1997 Emergency Plan Exercise

San Onofre Nuclear Generating Station

EXERCISE REVIEW COMMENT RESOLUTION

CUE CARD # 42

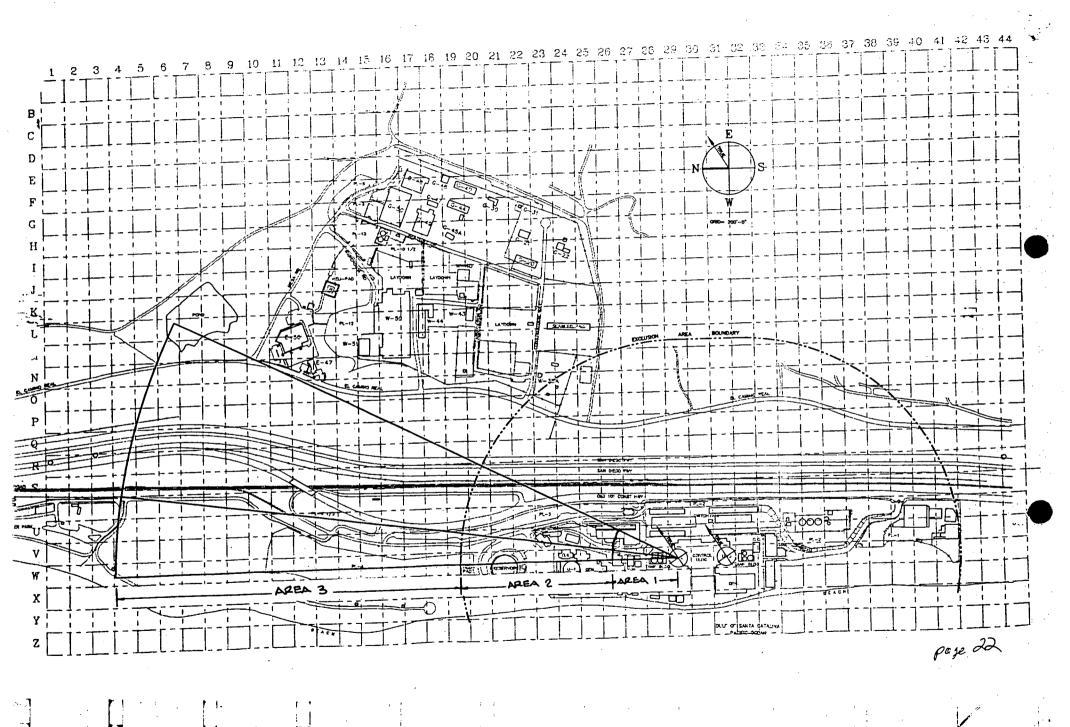
2) Comment: Cue Card #6 had an inconsistency between controller directions and a public address announcement for the General Emergency. Also, Cue Card #42 page 2 did not seem appropriate for the context of the cue card.

Resolution: Controller instructions in Cue Card #6 were revised to be consistent with the public address announcement, and Cue Card #42 page two was deleted.

Page 2 of 2 for Cue Card 42 has been deleted. Please replace it with this page.
